# Access Compliance Report

## Public Rights-of-Way

| Intersection ID: 21797                  | Main Street: GALLERIA_BV | Cross Street: MONROE_RD | Location: SE                            |
| ADA ID: 74C38542DCD7                    | Ramp Type: Perp          | Initial Pass/Fail: Fail | Overall Compliance: No                  |

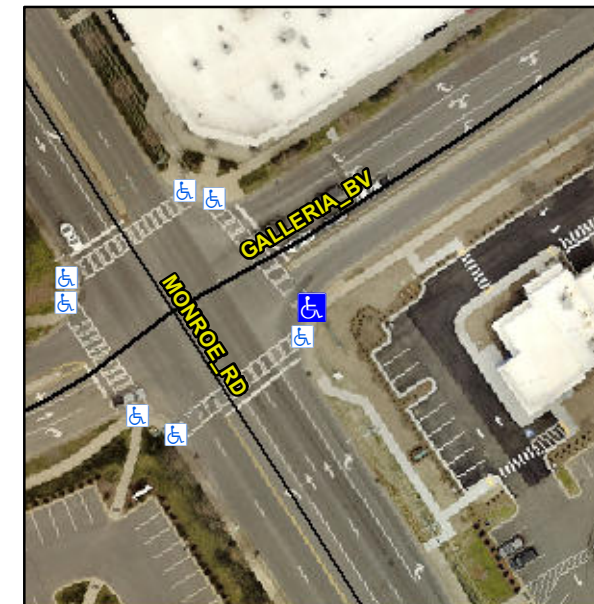
**R304.5.1, R304.5.3**

| Compliance | Description           | Data  | Compliance | Description                 | Data |
|------------|-----------------------|-------|------------|-----------------------------|------|
| N/A        | Ramp Length (in)      | 37.0  | Yes        | Ramp Slope (%)              | 5.8  |
| No         | Ramp Width (in)       | 41.5  | No         | Ramp XSlope (%)             | 4.1  |

**Remove & Replace Entire Ramp.**
